**CONSTRUCTION CONTRACT CHANGE ORDER NUMBER:** \_\_\_\_\_

CCSJ:	<u>0921-02-321</u>
Project:	<u>STP 2021(256) MM</u>
Highway:	<u>Mile 3 N</u>
County:	<u>Hidalgo</u>
District:	<u>21-Pharr</u>
Contract Number:	<u>C-20-294-02-23</u>

## Change Order #5 Mile 3 N Road

Project: Mile 3 N Road  
Project #: STP 2021 (256) MM  
Contract: C-20-294-02-23  
CSJ: 0921-02-321  
Limits: Tom Gill Road to FM 492 (Goodwin Road)

**MILE 3 ROAD  
PLAN AND PROFILE  
STA. 275+50 TO STA. 280+50**

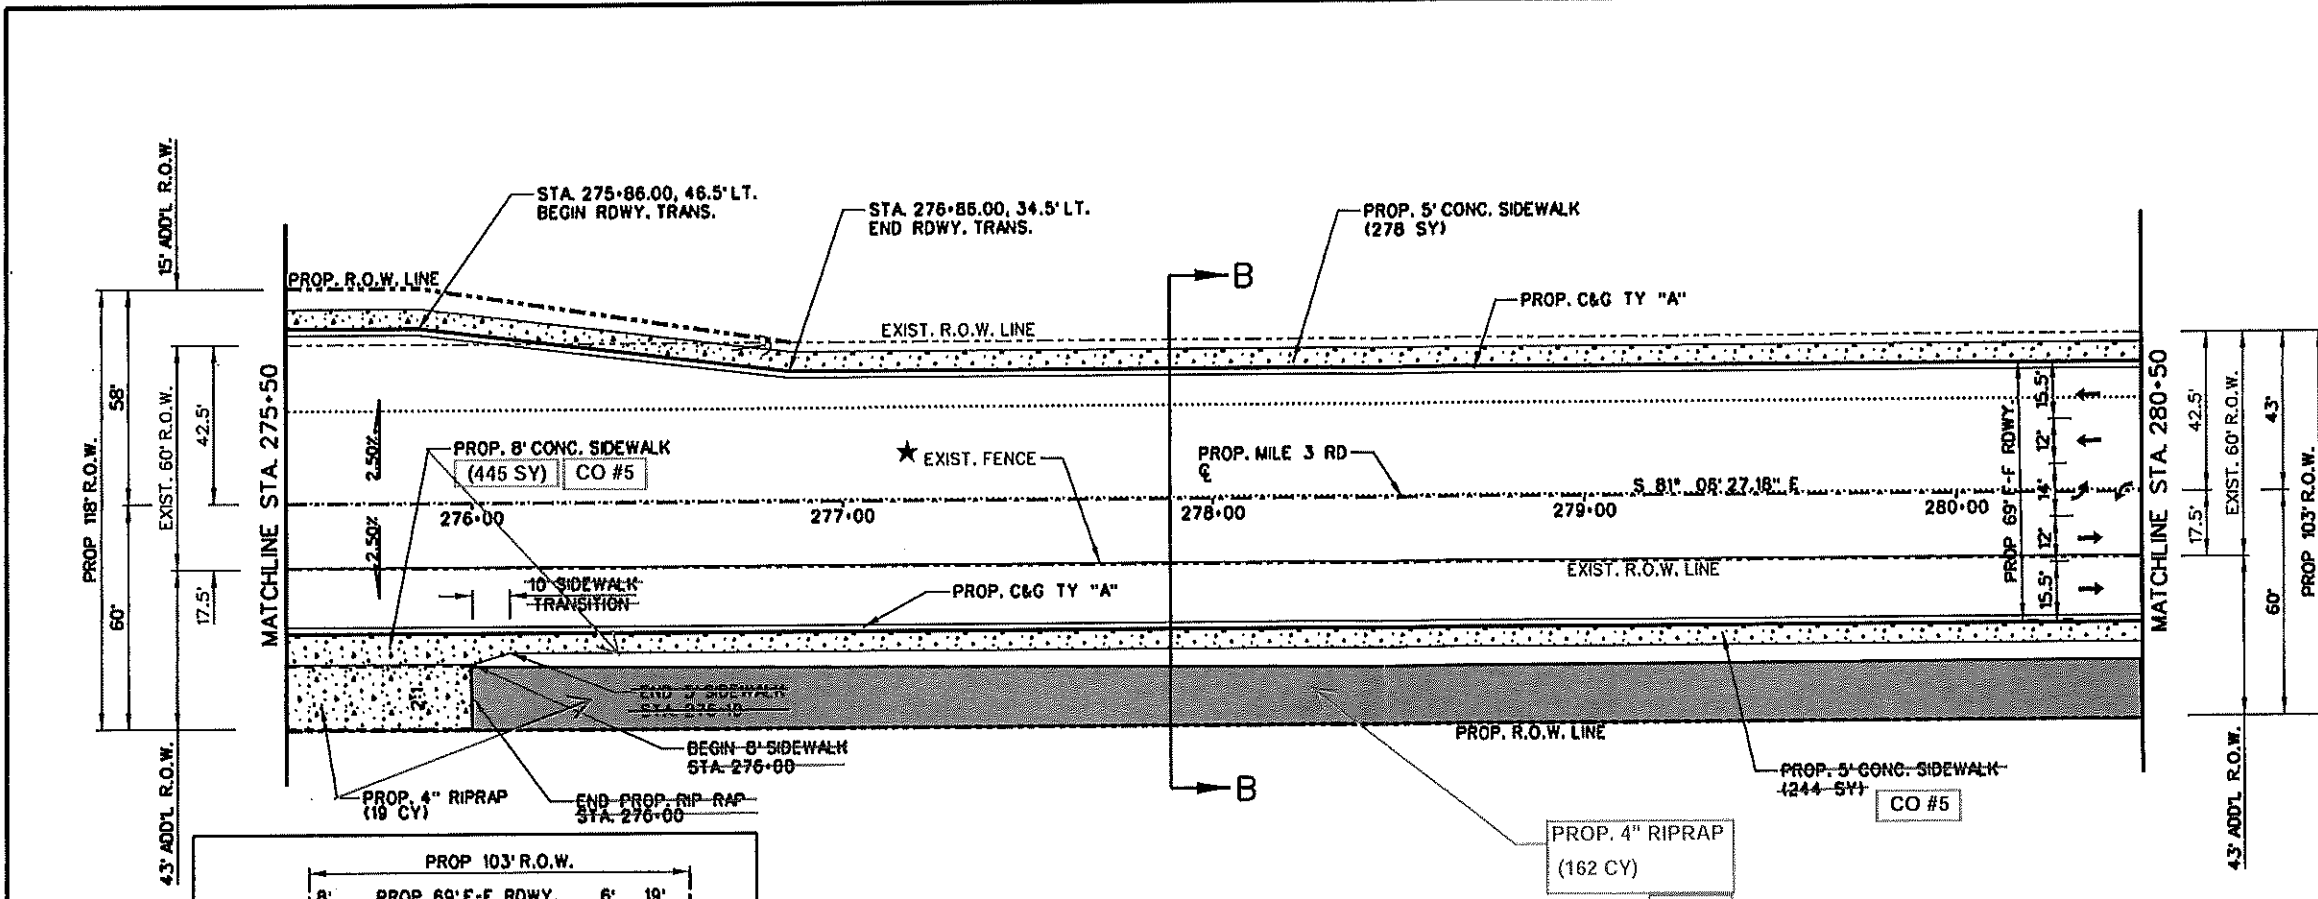
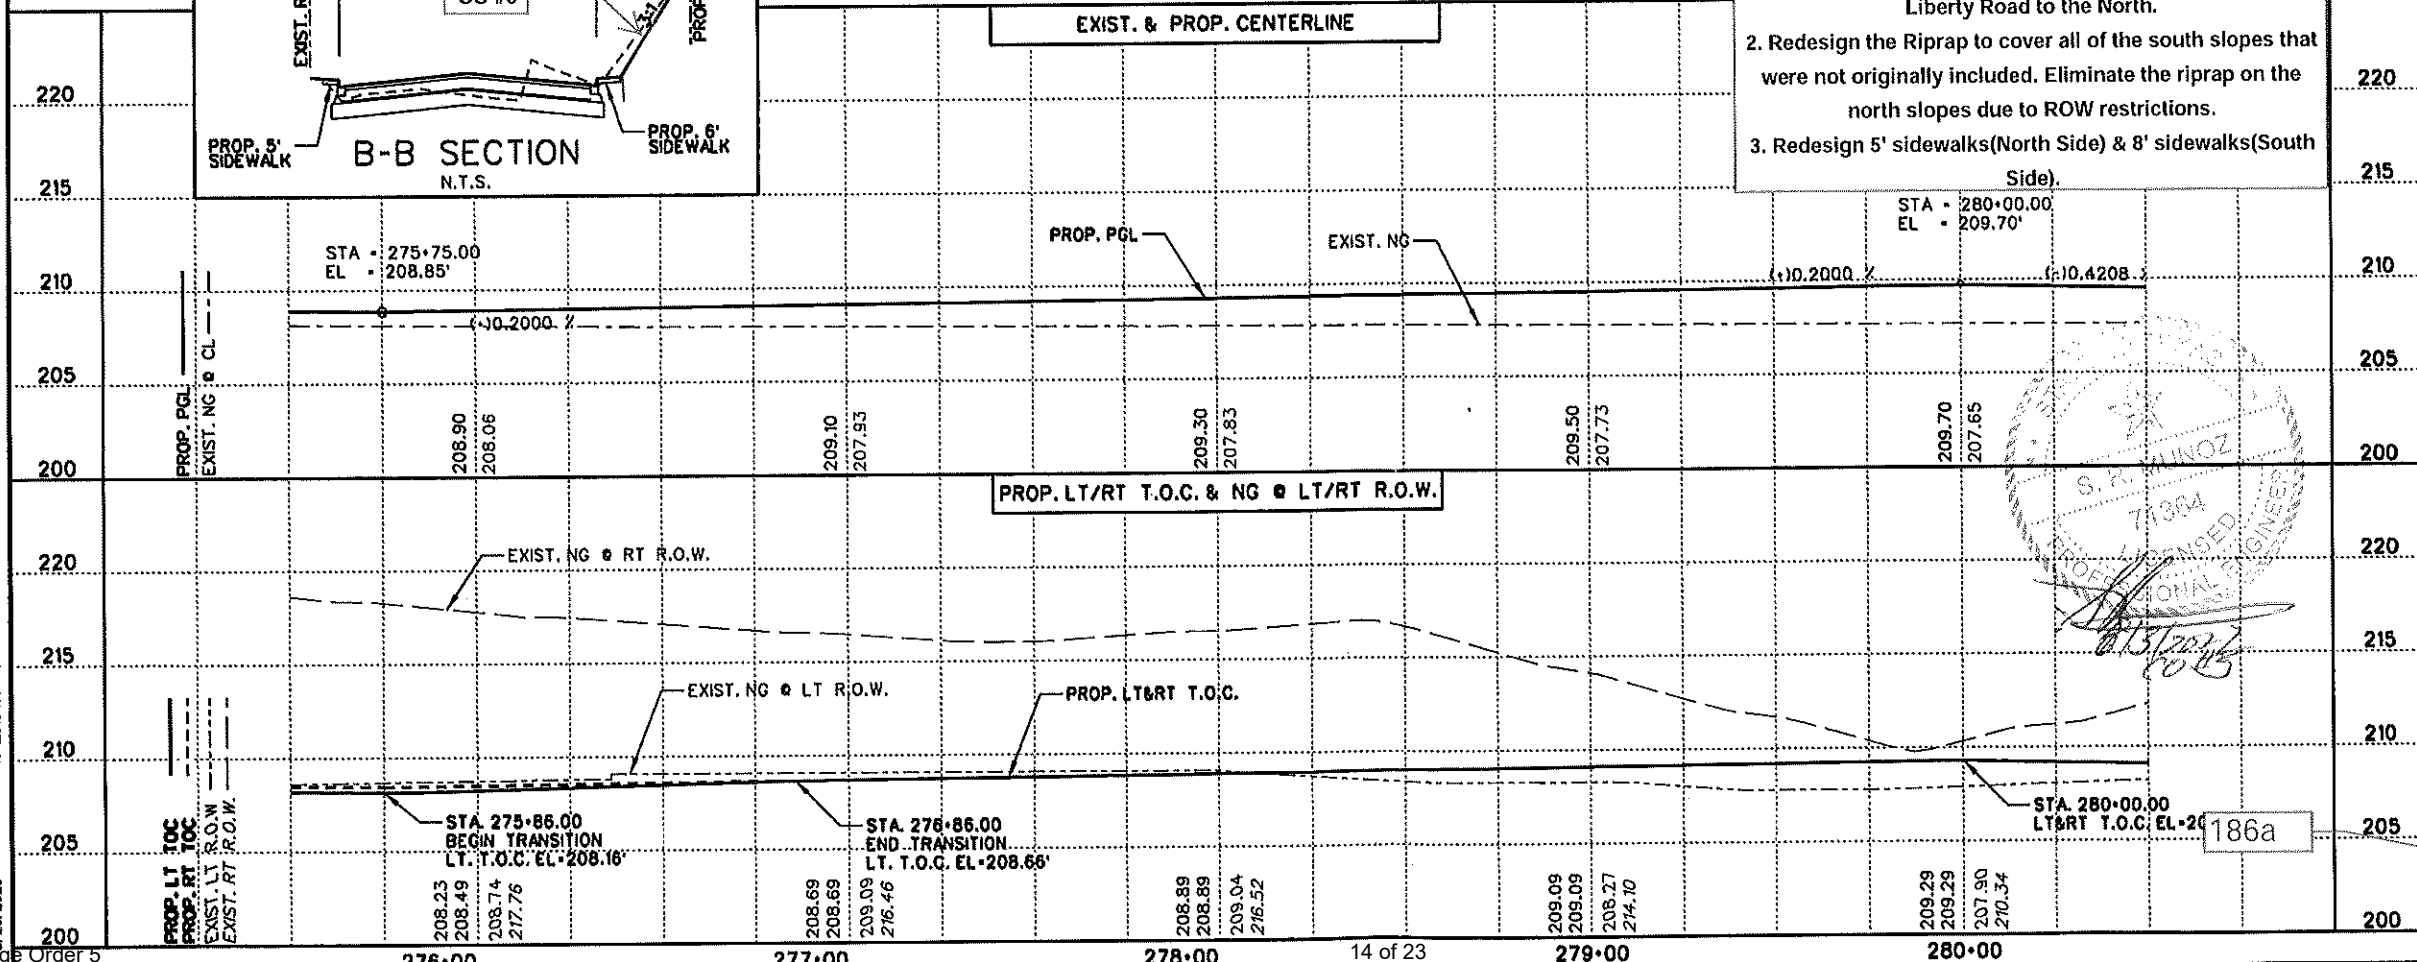
- Install 18" RCP and 2 - 3'x3' Inlets to provide drainage on Liberty Road to the North.
- Redesign the Riprap to cover all of the south slopes that were not originally included. Eliminate the riprap on the north slopes due to ROW restrictions.
- Redesign 5' sidewalks (North Side) & 8' sidewalks (South Side).

**MILE 3 ROAD  
 PLAN AND PROFILE  
 STA. 280+50 TO STA. 285+50**

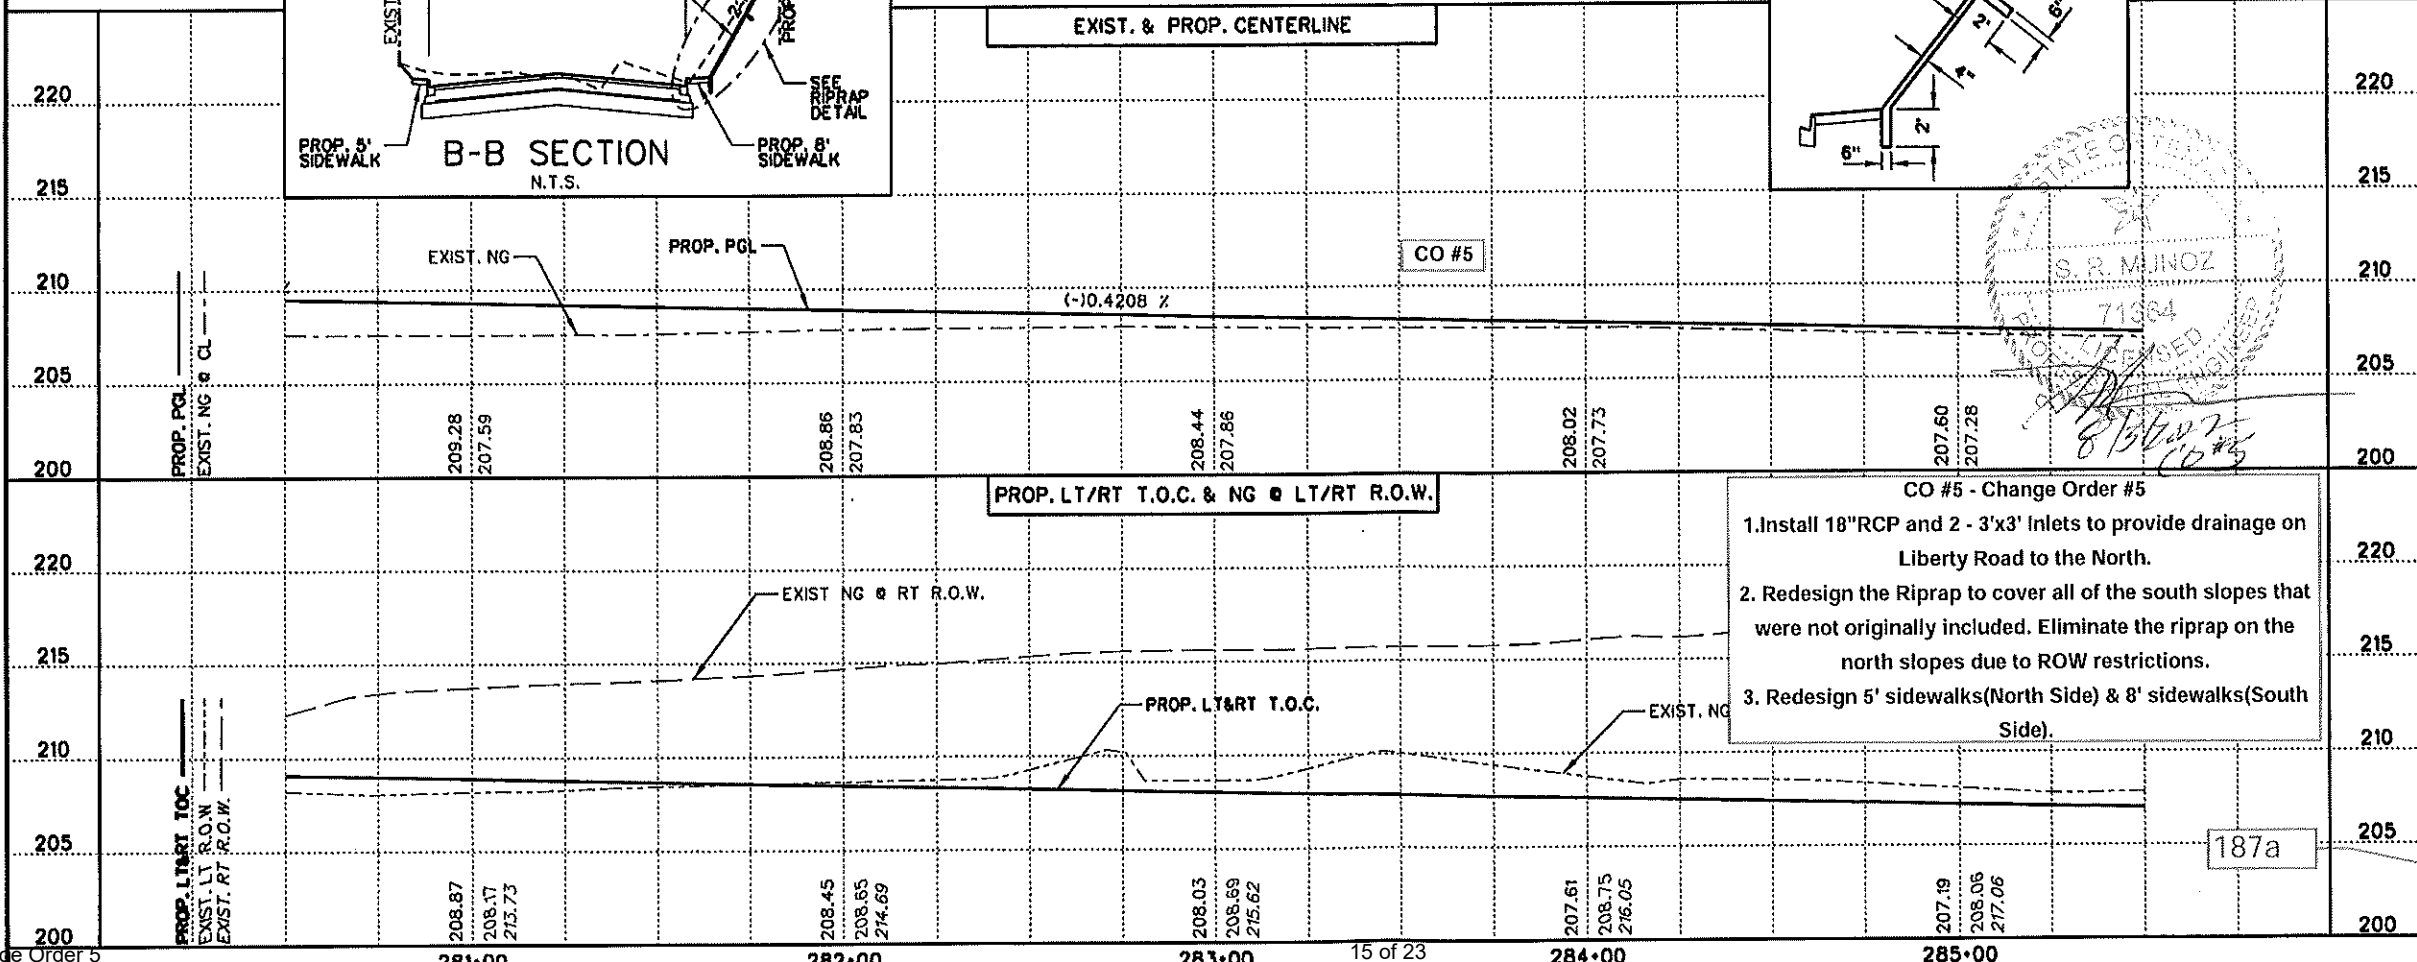
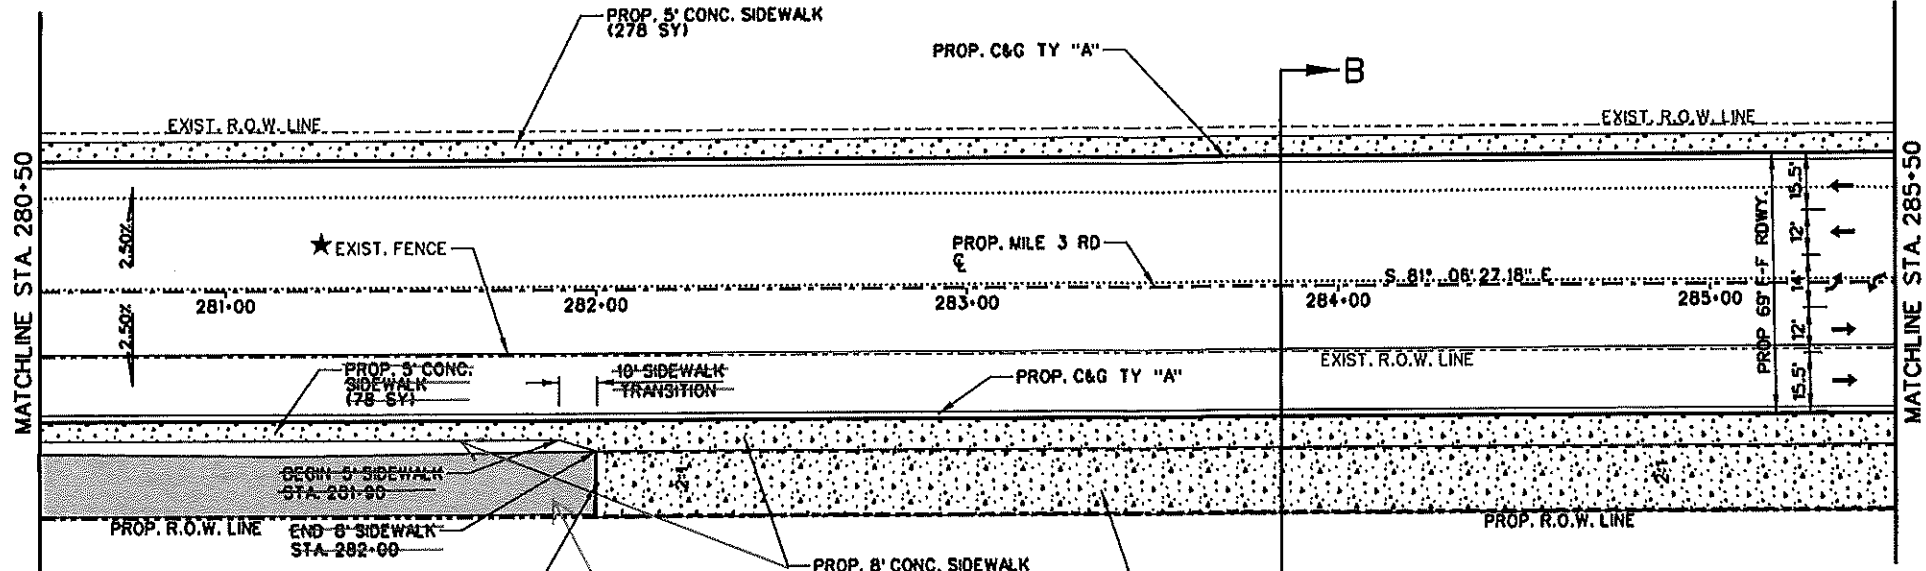
1. Install 18" RCP and 2 - 3'x3' Inlets to provide drainage on Liberty Road to the North.
2. Redesign the Riprap to cover all of the south slopes that were not originally included. Eliminate the riprap on the north slopes due to ROW restrictions.
3. Redesign 5' sidewalks (North Side) & 8' sidewalks (South Side).
